# CITY OF ALBUQUERQUE

RE: **Lot 39 Block 6 Volcano Cliffs Unit 18 SAD 228**  
**6623 Sujeto Rd. NW**  
**Grading and Drainage Plan**  
**Engineers Stamp Date; 2/28/2020(D10D003M39)**  
**Revised Date; 8/10/2020**  
**Pad Certification Date; 3/11/2020**

## DRAINAGE AND TRANSPORTATION INFORMATION SHEET (REV 6/2018)

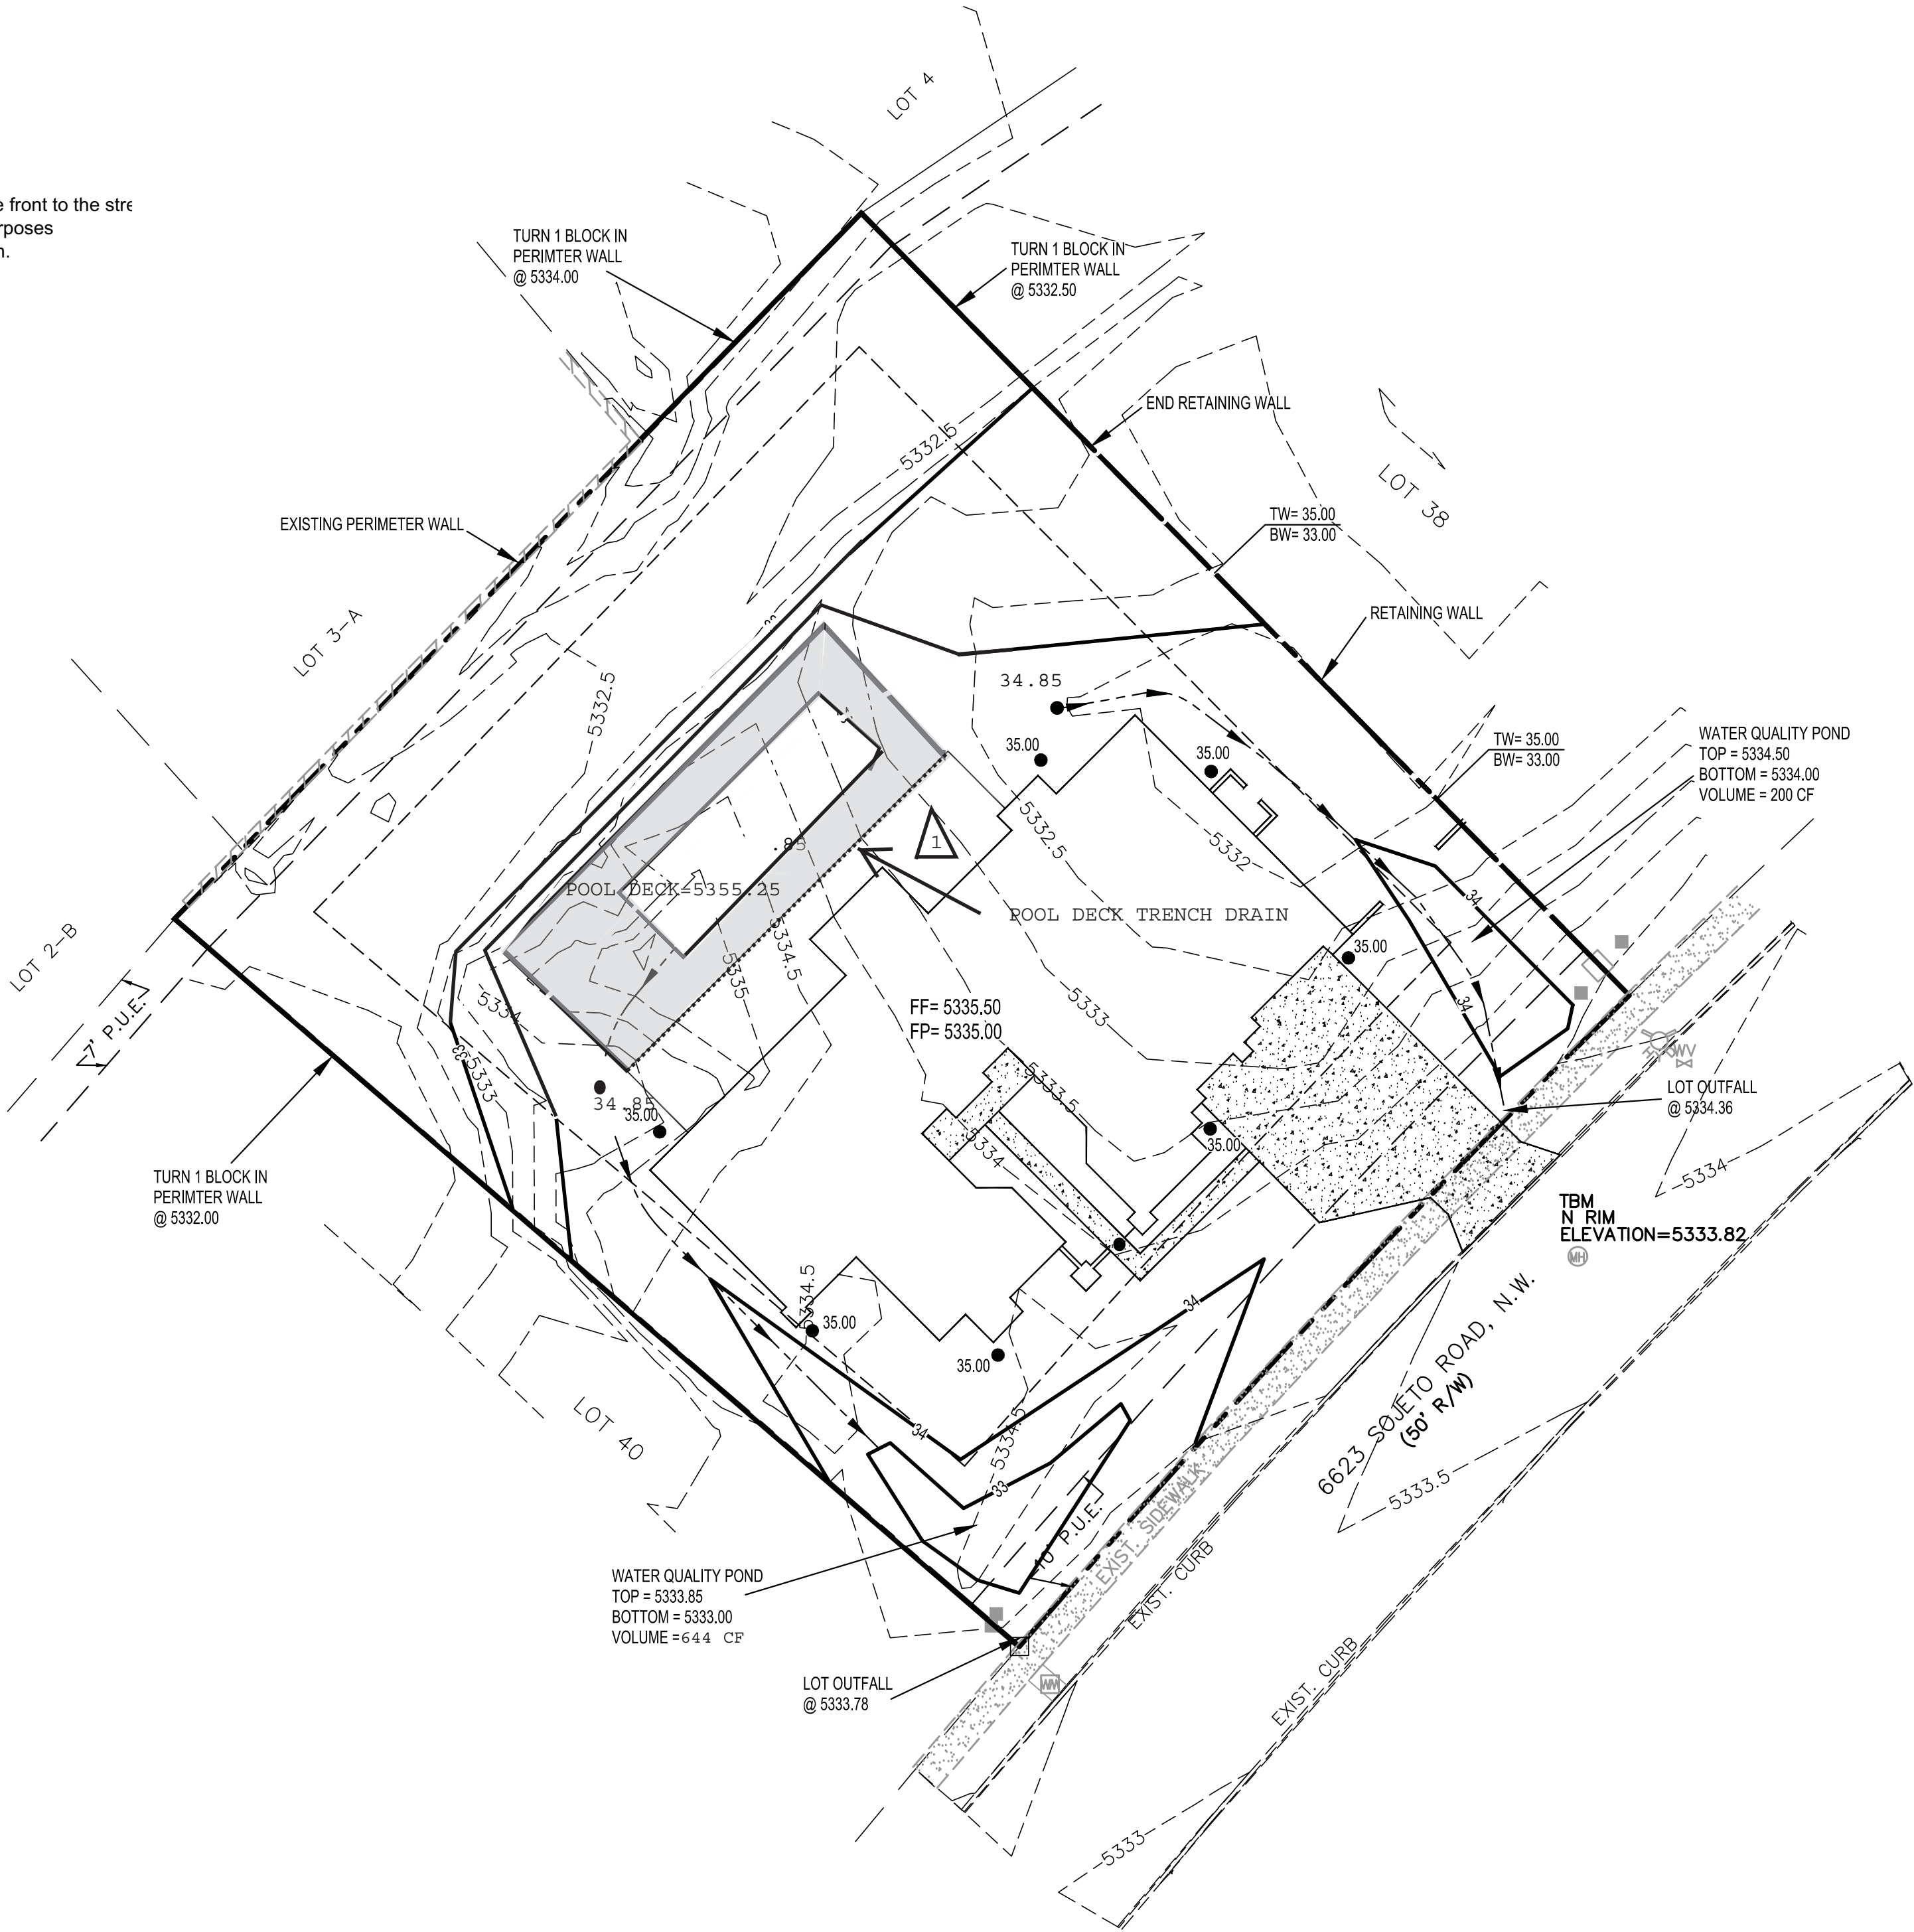
Based upon the information provided in your submittal received 8/12/2020, this revised plan dated, 8/10/2020 is approved for Building Permit.

**Reiterate to the Owner/Contractor that a separate permit for a garden/retaining wall must be obtained, with the approved G&D plan dated 8/10/2020 and Pad Certification Date 3/11/2020.**

Prior to Certificate of Occupancy release, Engineer Certification per the DPM checklist of this plan will be required.
